Product Change Notification (PCN)

PCN Number	511248	Date Issued	December 02, 2021
Reason for Change	Manufacturing Process Change (Molex)		
Change Type Description	This letter is to inform you that the manufacturing process for the part(s) identified in this notice is changing. No changes will be made to the product as a result of this process change.		
Assessment of Change	Product will be fully qualified before it is shipped. Qualification reports will be available after below listed date		
Internal Molex Qualification Date	March 18, 2022		
Sample Availability Date (Changed Part)	March 18, 2022		
Planned Implementation Date	May 12, 2022		
Method of Identifying Change	No special marking on the product or packaging

After Change

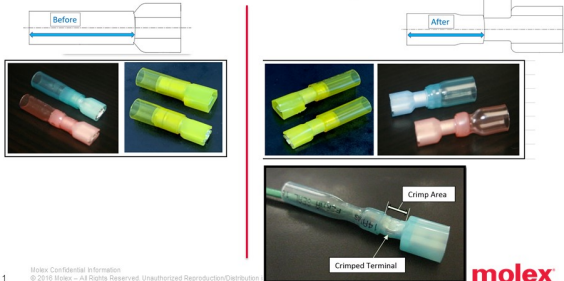
- Molex is realigning (shortening) the Heat-Shrink Tubing in order to provide a clear crimp area over the insulated conductor barrel. This will impact Perma-Seal Coupler Quick-Connects, Red 22-18 awg, & Yellow 12-10 awg.
- There's No Impact in overall length, fit, form or function of these products.
- These terminals are already UL/CSA Certified and crimped without heat shrink tubing in the crimping area.
- Part Number Impact There are (4) base parts impacted
